## **TRO10032 LOWER THAMES CROSSING SHORNE PARISH COUNCIL (IP ref 20035603)**

### **DfT letter requesting comments, dated 9th July 2024: Response to points 8 and 9 regarding Rest and Service Area provision**

*Tollgate garage (Image from Google Streetview, dated November 2022)*

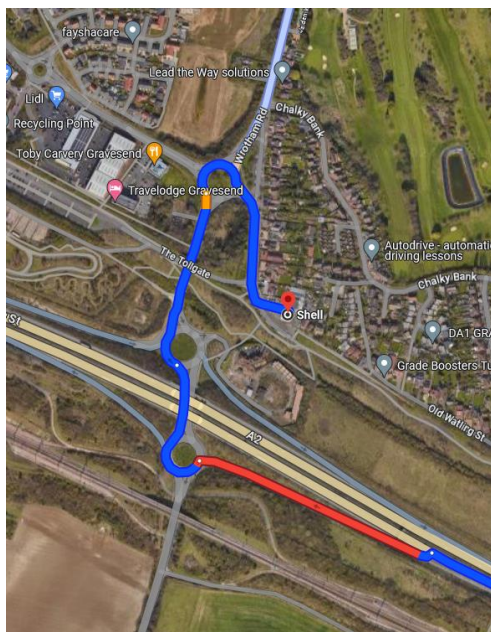
- To reach the garage from the A2 westbound involves negotiating three busy local road roundabouts. Although signposted, the location of the garage is unclear to non-local drivers. This overall area and the garage itself are not set up for or suitable for use by anything near the large volumes of cars, vans and HGV's that currently use the Cobham services.
